SERVICE AND APPLICATION NOTES

100007
June 23, 2021

Alternate Quantum Aluminum Replacement Coil for Air Handlers

CBX27UH, CBX32M, CBX32MV & CBX40UHV Elite and Dave Lennox Signature Collection Air Handlers with Copper Coils

Quantum Aluminum Replacement Coil

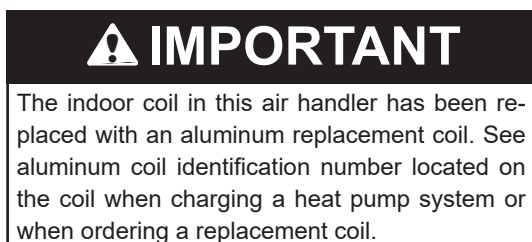
The Quantum replacement coil has reduced internal volume when compared to the existing copper coil which can create a coil volume imbalance in the system. This change in coil volume means not all heat pump applications can utilize the Quantum Coil. Heat pumps that can use the Quantum replacement coil will require using the updated refrigerant charge instructions. If the coil is replaced and the coil volume imbalance is too great or the new charge instructions are not followed, the system will not perform as expected and will likely experience high pressure switch trips in mild weather heating situations. The Quantum replacement coil is provided with updated refrigerant charge labels, coil cleaning instructions and labels to communicate that the air handler has been updated with a Quantum Coil.

The Quantum replacement coil internal coil volume is less than the existing copper coil which will impact the system refrigerant charge on heat pumps systems. The replacement Quantum coil is provided with a set of updated heat pump charging labels. When the Quantum replacement coil is installed on a system with a heat pump outdoor unit, the system should be charged using charging procedure provided on the updated charging label that includes the addition of the Quantum aluminum coils. The Quantum aluminum coils will be listed as CBA27UHE-xxx or CBA38MV-xx on the label. An example of the updated heat pump charging label is provided below.

- 1 - Complete Quantum Aluminum Coil Assembly with an upflow drain pan and a factory installed check / expansion valve.
- 1 - Replacement Coil Installation Packet:

- C - Aluminum Coil Cleaning Instruction Label for installation on the air handling unit cabinet.
 - D - Set of Updated Heat Pump Charging Labels:
 - The charging labels include updated refrigerant charging information for the heat pump with the Quantum aluminum replacement coil. The new charging label is installed on the control box cover of the heat pump in place of the original charging label.
